**Dyno load setting –  
time between warm up and coastdown**

M. Bergmann, AUDI

# Time between warm up and coastdown - current gtr text

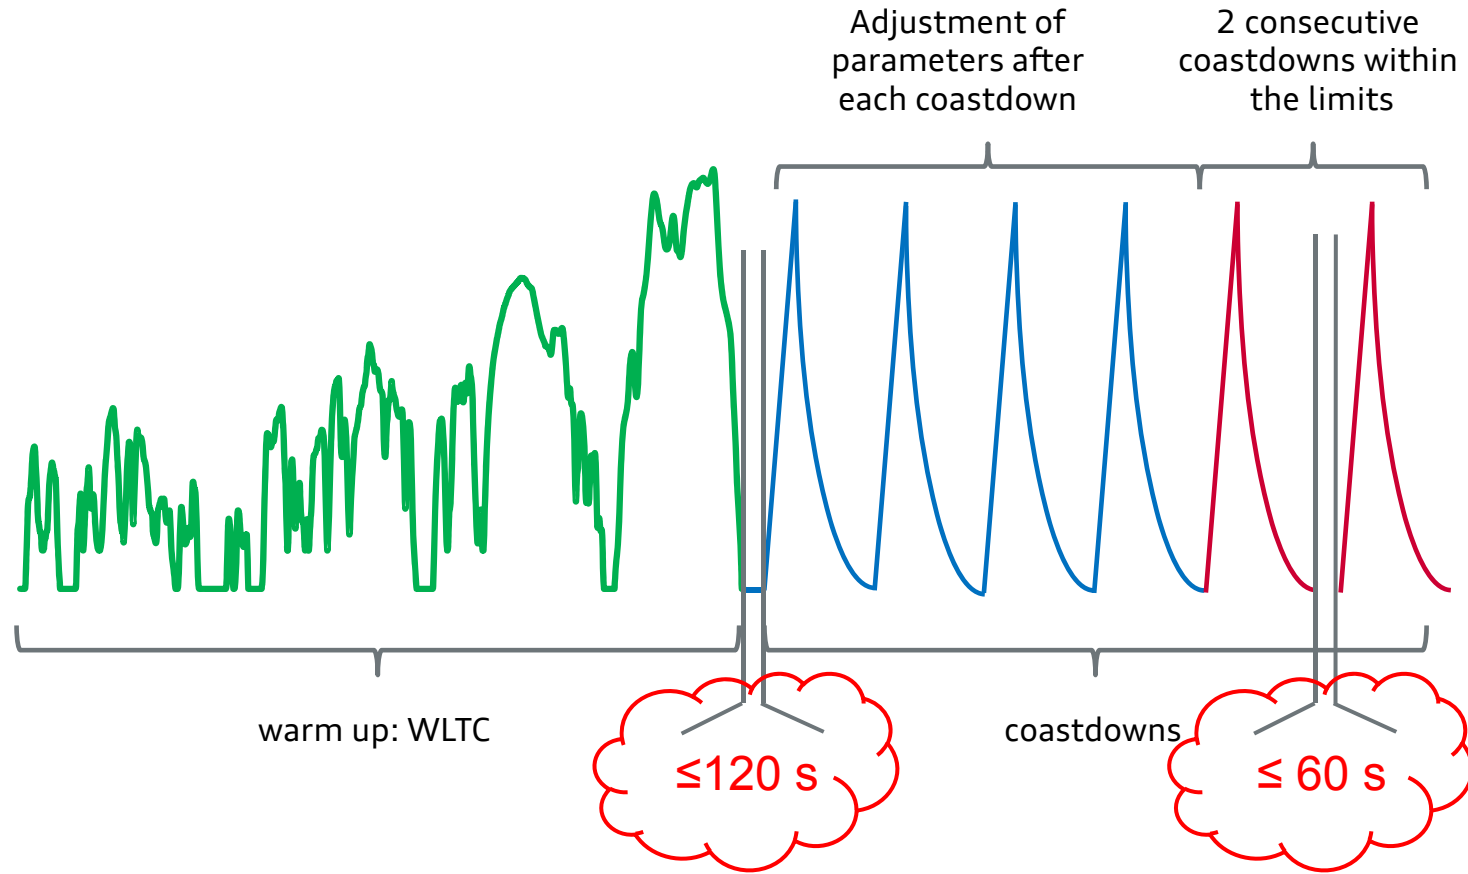
- ▶ Time between warm-up procedure and actual coastdown and inbetween individual coastdown runs is not defined

- ▶ concern:
  - ▶ The maximum time between vehicle warm up and start of the 1 minute run at the highest reference speed is not defined/limited.
- ▶ Proposed text
  - ▶ 8.1.2. Coastdown

The coastdown test on the chassis dynamometer shall be performed with the procedure given in paragraphs 4.3.1.3.1. and 4.3.1.3.2. of this Annex **and shall start at latest 120 s after completion of the warm up procedure. The time between consecutive coastdown runs shall not exceed 60 s.**

**At the request of the manufacturer and with approval of the responsible authorities, the time between the warm up procedure and the coastdown can be extended to ensure a proper vehicle setting for the coastdown. The manufacturer has to give evidence to the responsible authorities, that the additional time does not affect the parameters for the chassis dynamometer load setting.**
- ▶ Justification:
  - ▶ A certain time between warm up and coasting may be needed to set the dyno, automation system, coastdown mode and/or autopilot to load setting mode
